RE: **Waiver Approval**
6965 Mink Hollow Road
Highland, MD 20777

We are planning to build an addition to our home and are writing to request a variance to the (1) Well and Septic Program required setback distances, and (2) Percolation Test Requirements.

PLOT PLAN

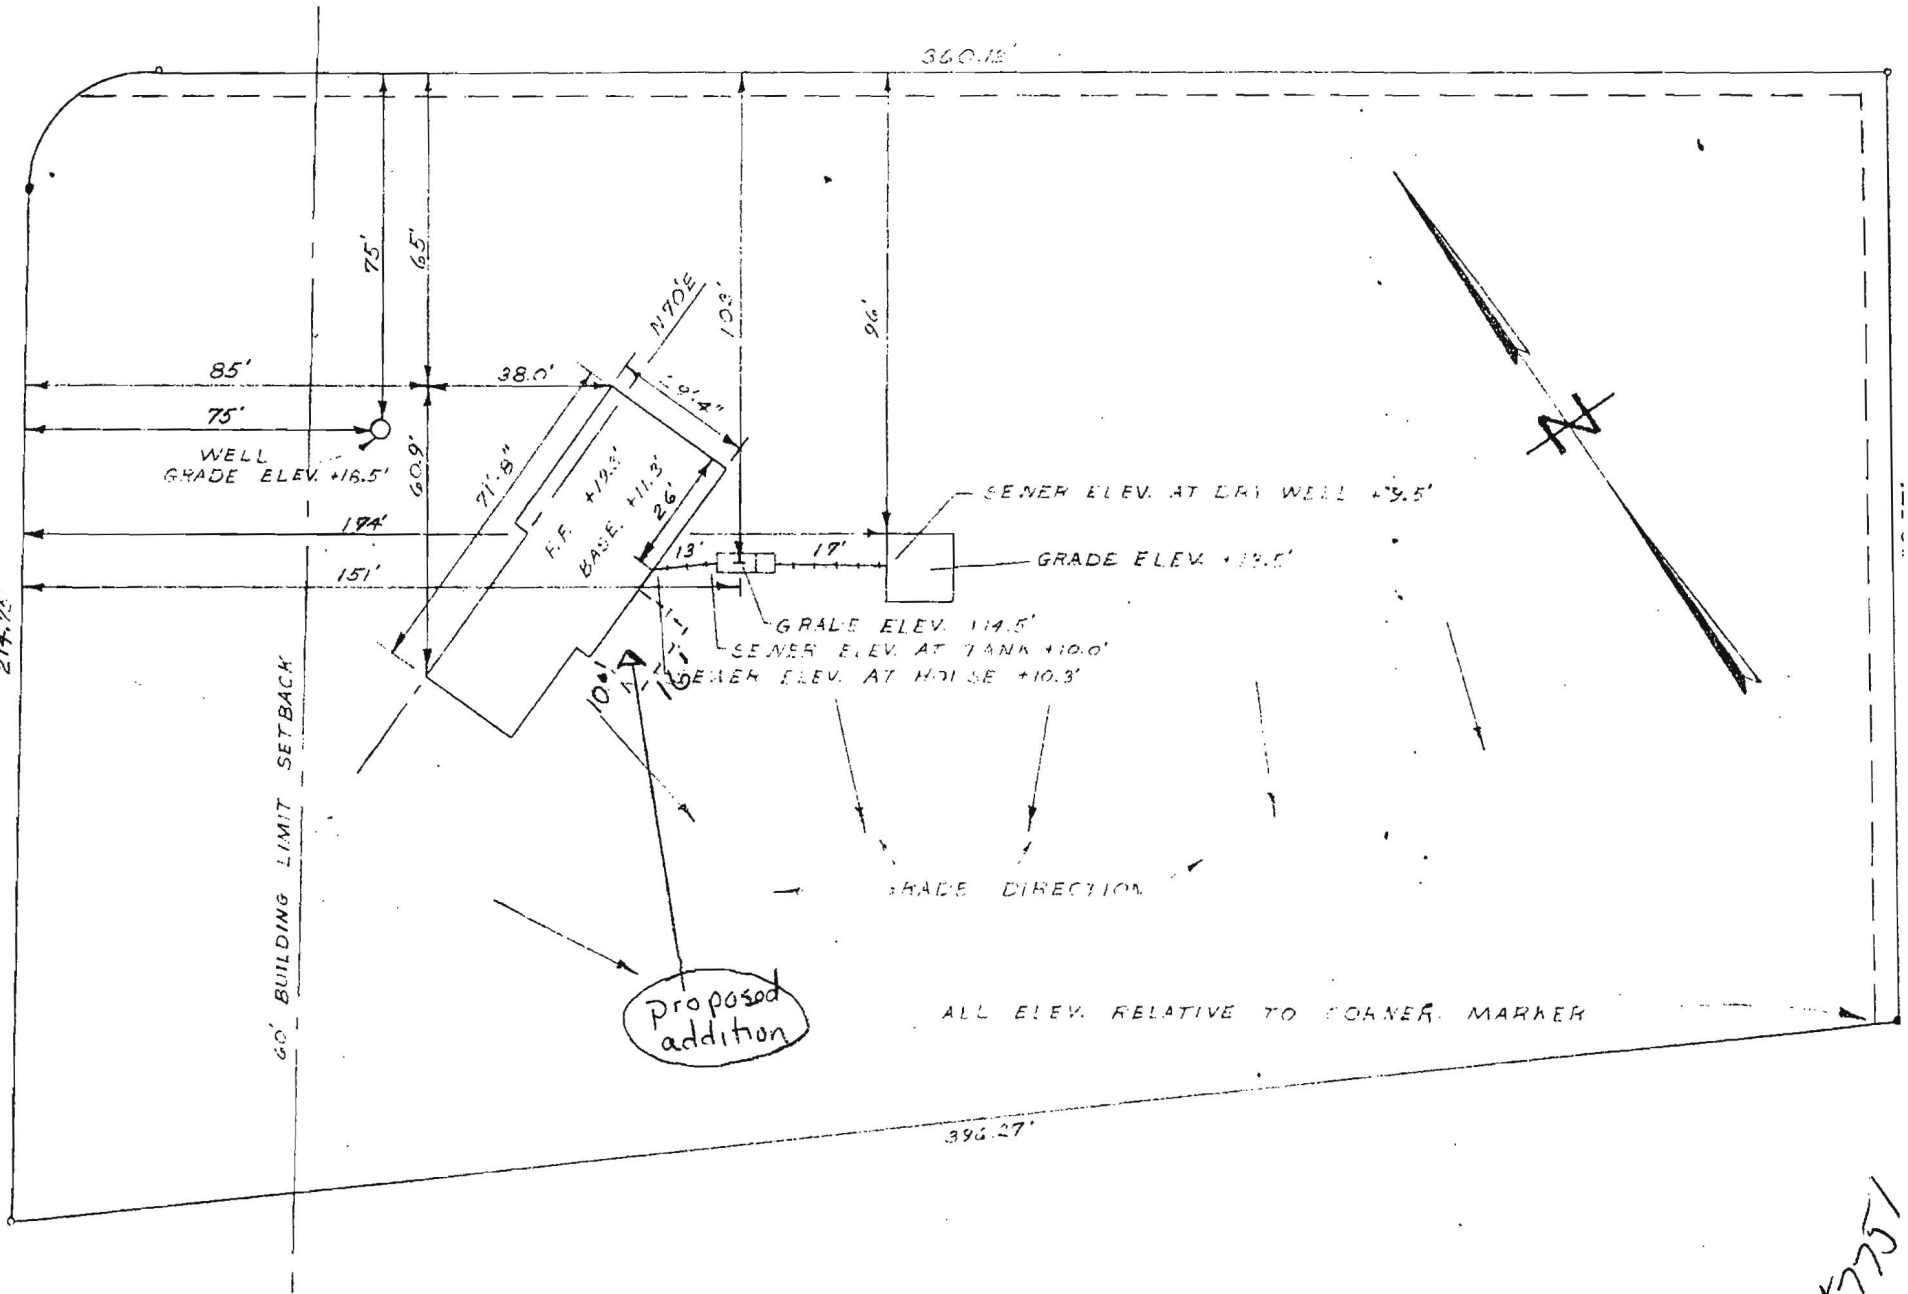
Our plan is to "bump-out" our kitchen by 10 feet. The square footage of this addition will be about 160 square feet. Unfortunately, if we construct our addition as planned, the result will be that the septic tank in its current location will be 10 feet from the "new" foundation. Since we are planning to build a basement foundation for this addition, the proposed addition will not be in compliance with the current setback requirement (septic tank to house with a basement) of 20 feet.

I am including a copy of our plat (see page 3) which will show the existing structure and the location of the proposed addition. The proposed addition is drawn on the plat document in dashed lines and is labeled as "proposed addition". It also identifies the location of the septic tank and drywell. I have also enclosed a copy of the original septic permit and the septic construction plan (pages 4 and 5), which will show the location of the drain field and reserve drain field. To provide additional detail on the addition, I am including a rendering that was prepared by our architect (pages 6 and 7). The first page will show the floor plan and dimensions of the proposed addition, and the second page will provide the elevation view and will provide a sense of the grade.

The Health Department has received your waiver request to allow the existing septic tank to be ten (10) feet from the proposed addition and waive percolation testing to establish a sewage reserve area for future repairs. The waiver has been approved on the basis that the addition does not increase wastewater generation from the home and has little impact on future sewage disposal repair area. Any deviation from the plan submitted with the waiver request will require review by this Department.
